Carranstown Site, Co. Meath		
Soil and Groundwater Monitoring Locations		
K.T.Cullen & Co. Ltd. Hydrogeological & Environmental Consultants	Job No. 2175 Date: May 2000	Figure 3

#March 2005 Submission to the Chairperson of E.P.A.
 Oral Hearing Boyne Valley Hotel Drogheda.
 Re: Waste Licence for Proposed Incinerator Dundave.

Indaver Ireland Ltd
 Project Management Group
Waste Management Facility, Carranstown
Adjacent Land Uses

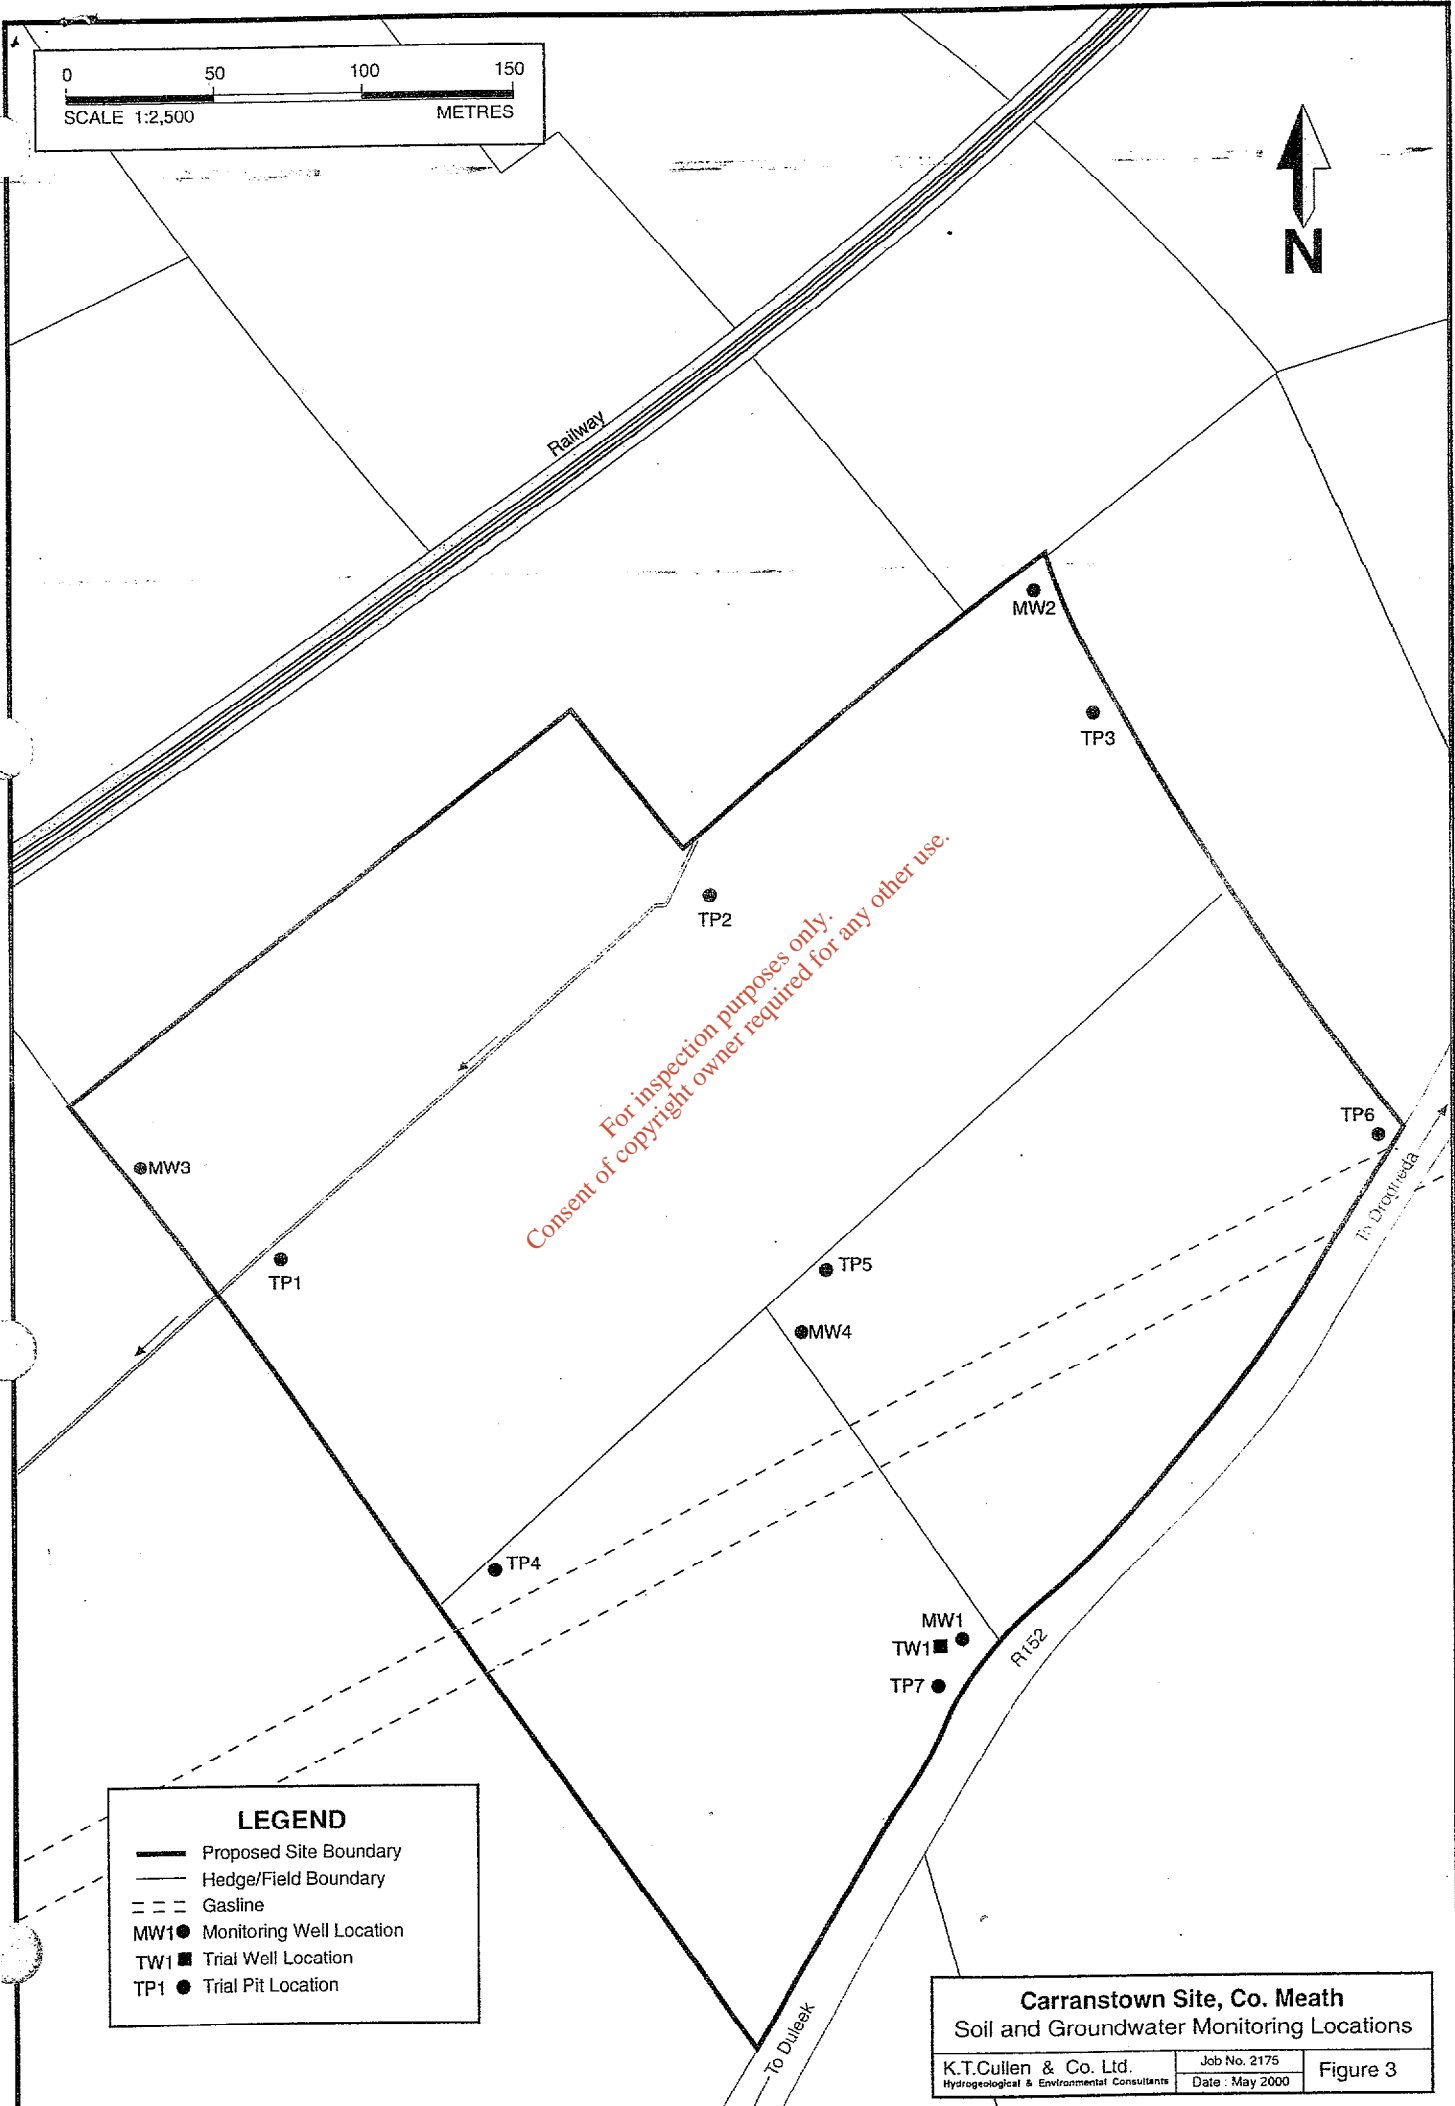
STEP 1 of which was ELIMINATE UNSATISFACTORY AREAS. Included in such areas were: Areas with Limestone Deposits; Areas critical for aquifer recharge; and areas of High Well Yield. All three of which apply to the Carranstown Site.

In the same document they admit that the area they have chosen "Constitutes a Regionally Important Aquifer, which displays both Karst and Fracture features". Both of which would rule it OUT on the W.H.O. criteria.

They then go on to state in that document, that "The aquifer vulnerability for this site is considered MODERATE (By them) under the G.S.I. guidelines for aquifer protection, EVEN THOUGH the HYDROGEOLOGICAL MAPS FOR THE AREA IN QUESTION (held in Beggars Bush) show that part of the original site for which Planning Permission was sought is actually rated as EXTREMELY VULNERABLE and the remainder of the site is rated as HIGHLY VULNERABLE (both of which rule the site out on W.H. O. criteria. The maps in question are those drawn up by the Hydrogeological Survey of Ireland and are obtainable from their headquarters in Beggars Bush, Dublin 4.

The E.P.A. Inspector's report states that the Vulnerability of the site in question is HIGH, (not Moderate as stated by INDAVER).

The area of the site which was retrenched by Indaver "Illegally?" from the original site for which Planning Application had been made, is actually "EXTREMELY VULNERABLE" and when I asked Mr. John Aherne why they
